SR-2000 6MEG IF and 2nd 1650 IF AMP IMPROVEMENT.

ORIGINAL
WIRING

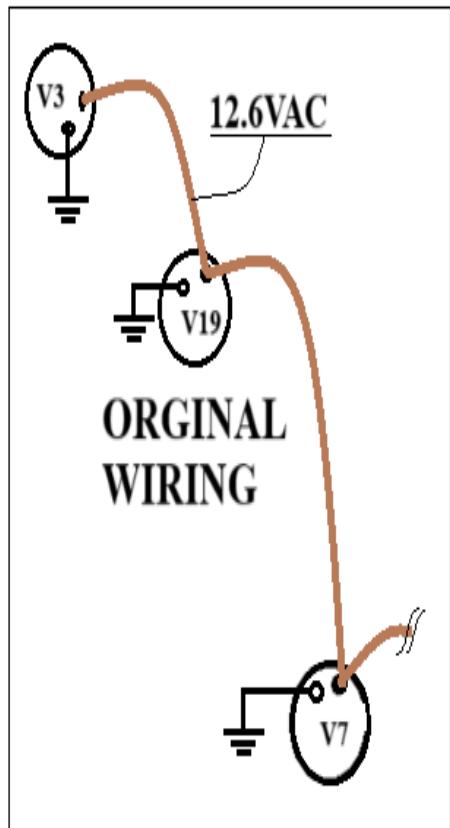
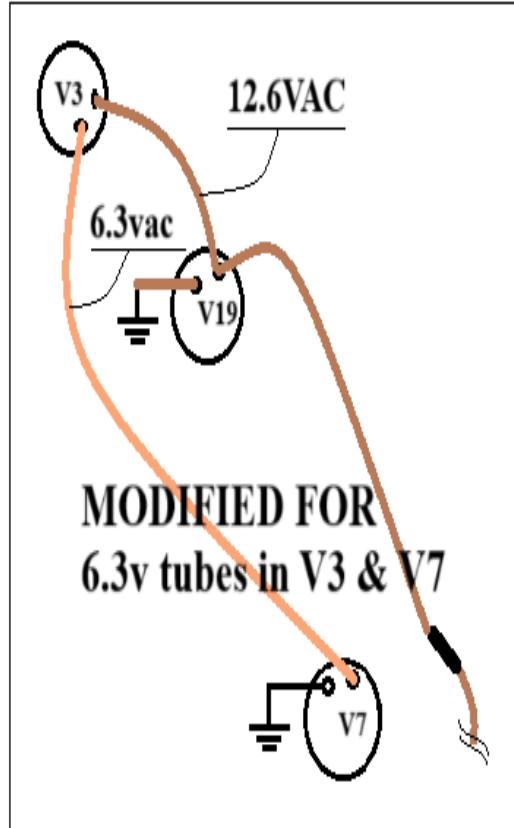
The problem can be easily solved by replacing V3 with a 6BL8 and V7 with a 6EA8/6GH8. The tube pin-outs are identical. Only the filament wiring needs to be altered.

A, Remove 2 brown wires from V7 pin 5. Splice the two wires together cover with heat shrink tubing and tuck out of harm's way.

B, Remove the ground wire from pin 4 of V3. I recommend complete desoldering of pin 4 and completely remove the jumper wire.

C, Connect a brown/white wire from pin 4 of V3 to Pin 5 of V7. I use a brown wire with a white tracer to differentiate from the 12.6v line. A brown wire with any color tracer will do.

MODIFIED FOR
6.3v tubes in V3 & V7
